RE: 16484 Kennedy Road - Parcel 1

I reviewed the drawings and evaluated the site context. My comments and recommendations are as follows:

EXHIBIT 10

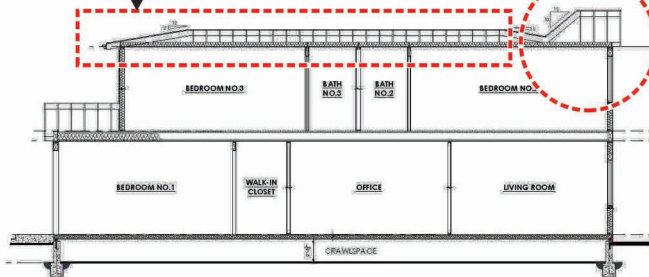
1:12 and 10:12 roof pitches do not work well together

Truncated gable roof ridge is awkward and not consistent with the architectural style

Shallow 2:12 roof slope is not consistent with the remainder of the design and the architectural style

Two-story unarticulated wall is not consistent with Residential Design Guideline 3.3.3

Terminating the stone base in the same plane as the siding is not consistent with Residential Design Guideline 3.8.4

Shallow 2:12 roof slope is not consistent with the remainder of the design and the architectural style

Truncated gable roof ridge is awkward and not consistent with the architectural style

Cacophony of roof and building forms does not seem consistent with Residential Design Guideline 3.5.2

Terminating the stone base on the outside corner is not consistent with Residential Design Guideline 3.8.4

Terminating the stone base on the outside corner is not consistent with Residential Design Guideline 3.8.4
